Refer to: 0430555004 – DuPage County  
Lisle/Lockformer  
Superfund/Technical Reports

The Illinois Environmental Protection Agency (Illinois EPA) has reviewed Clayton's Technical Memorandum *Confirmation Sampling Plan for Areas 1, 2 and Former Degreaser Area, April 17, 2003*, prepared by Clayton Group Services for the Lockformer site. We have the following comments:

FIGURE 1

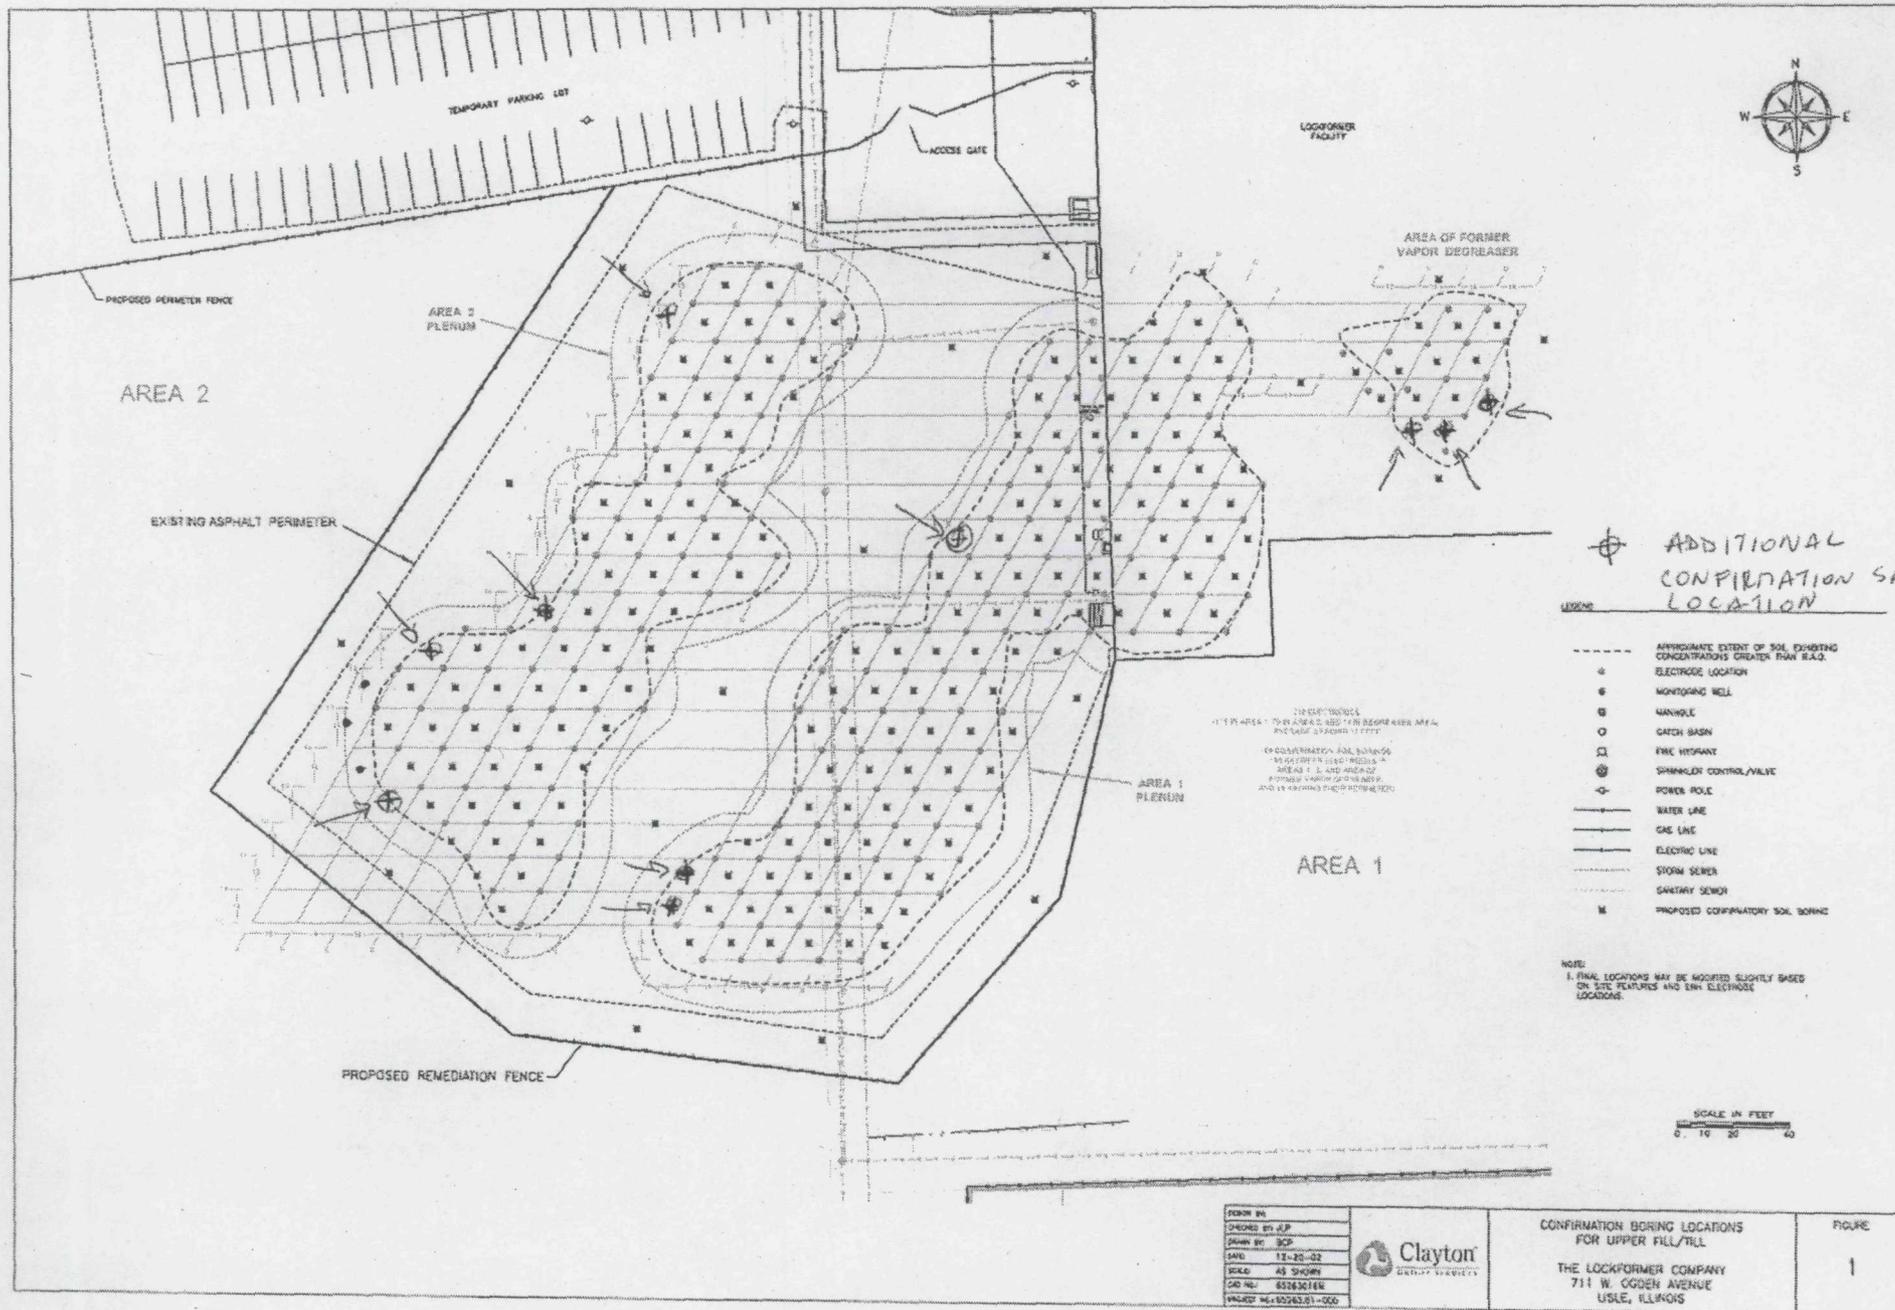
2. Page 2, The “theoretical electrical energy input” for each of the sub-areas is not well-defined.
3. Figure 1, Three additional confirmation soil borings are needed in the southern portion of the former vapor degreaser area. (See Figure 1)

4. Figure 1, Additional confirmation soil borings are needed around the perimeter of Areas 1 and 2 in several locations. (See Figure 1)
5. Page 5, In the event that a sub-area fails the confirmation sampling, and requires additional heating, an additional confirmation sampling plan will need to be developed in conjunction with USEPA and Illinois EPA that adequately addresses the sampling locations which originally failed. The sampling plan may be less stringent than the current plan for each area, depending on area-specific data.
